# LOWER FALLS IMPROVEMENT ASSOCIATION RIVERSIDE COMMITTEE

## **PRESENTATION TO THE LAND USE COMMITTEE**

**March 24, 2020**

## Design Guidelines

## Grove Street Design:

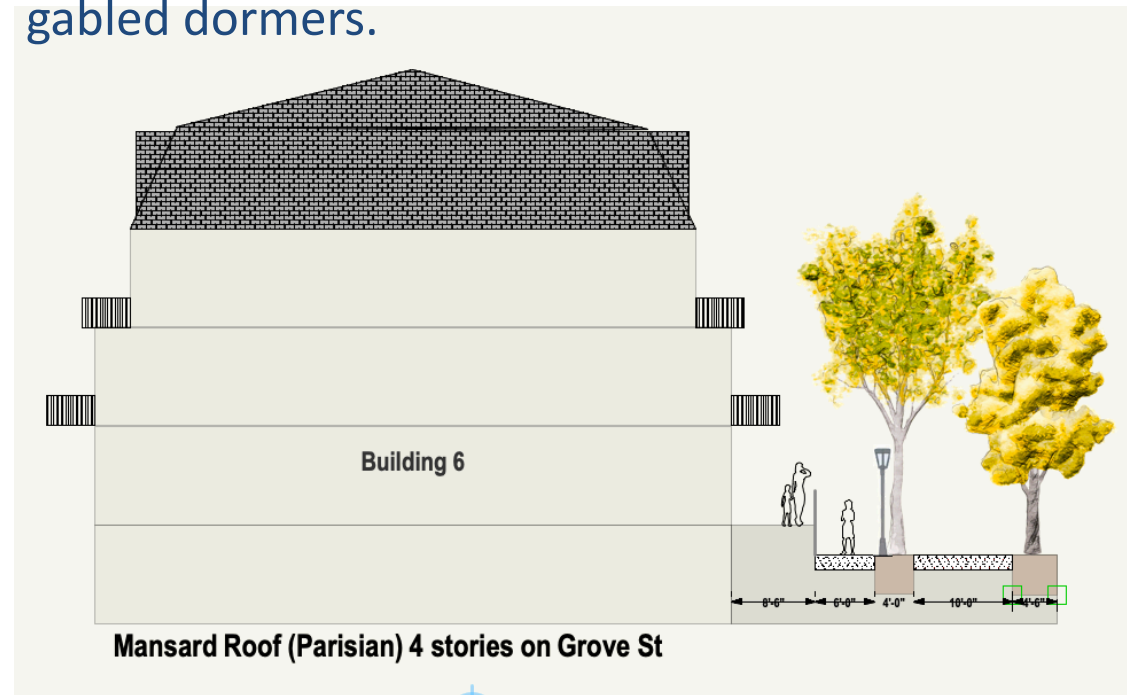
- Plantings and trees in setbacks, setbacks if possible
- Buildings with historic character – e.g., mansard roofs, old mills, Boston's South End
- Brick and/or stone, not vinyl clad
- Arched window heads
- Balconies
- Facade broken up to avoid 200 feet of monotony, yet with a consistent theme
- Buildings 5 and 6 – primary façade needed

## Grove Street Design

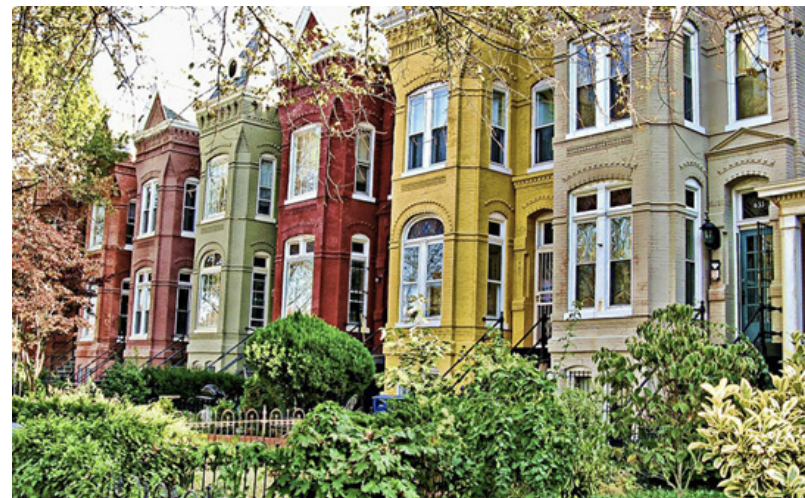
- brick/stone finishes
- arched window heads

## Officer Tower Design

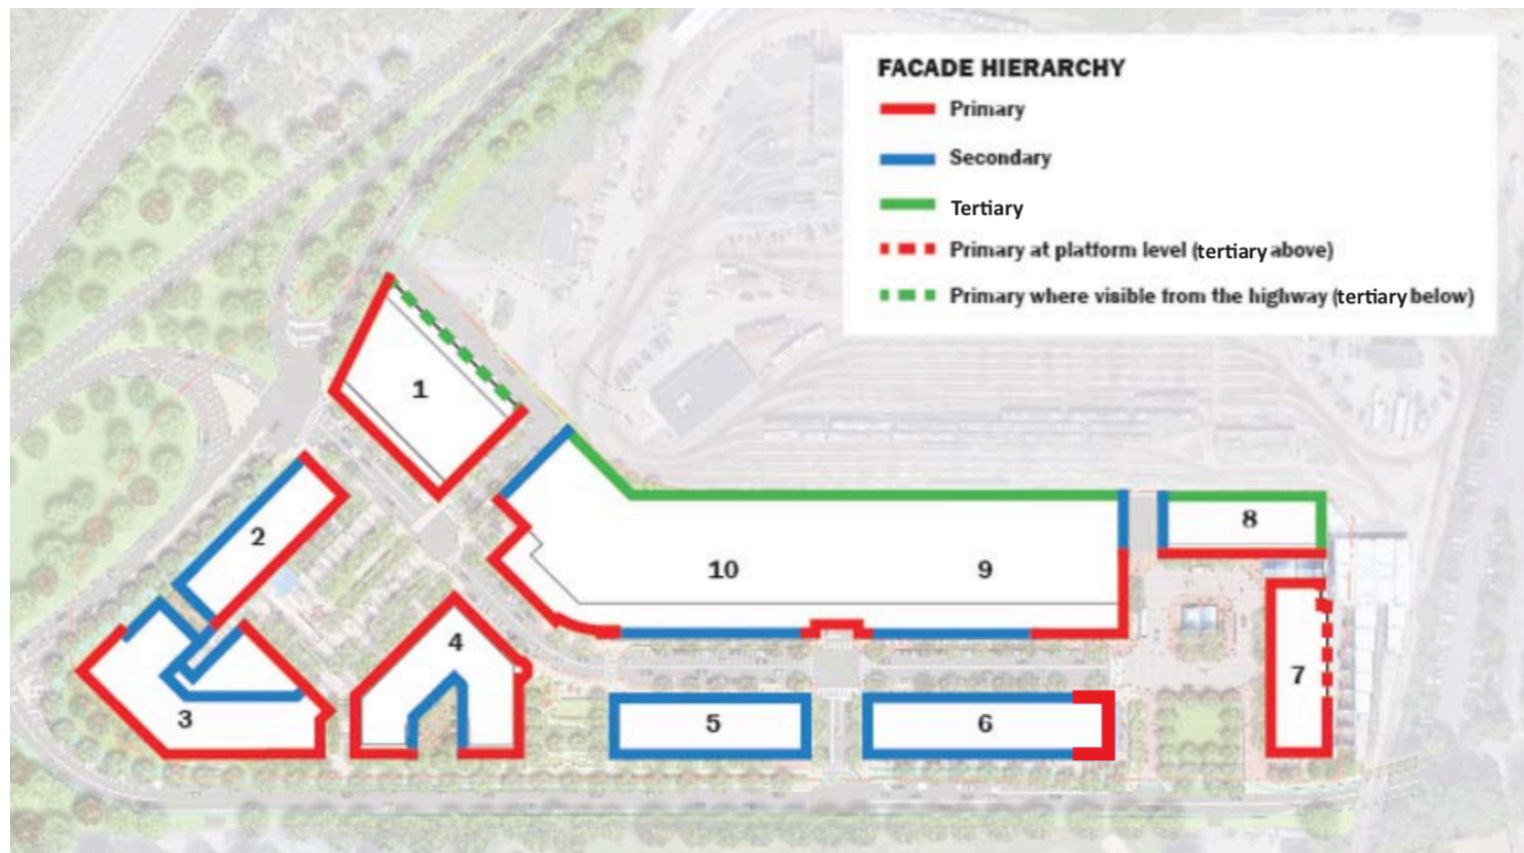
Least preferred

Better

## Signage – Generally

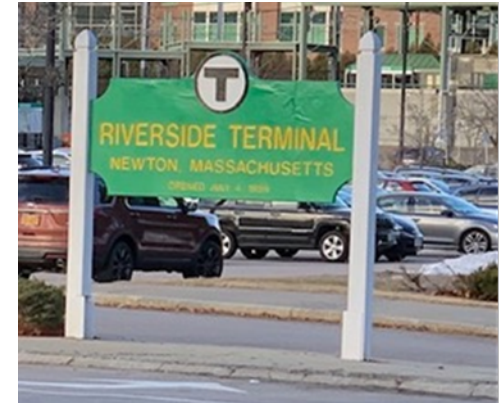
- Lighting :
  - Minimize internal illumination; prefer “halo”
  - Maximize indirectly lit
  - No neon
  - All internal illumination off between 11 PM and 7 AM
- Support: no freestanding sign except wayfinding (to be static, no advertisements)
- Support: no sandwich signs
- Leasing signage : same limitations as Newton sign ordinance
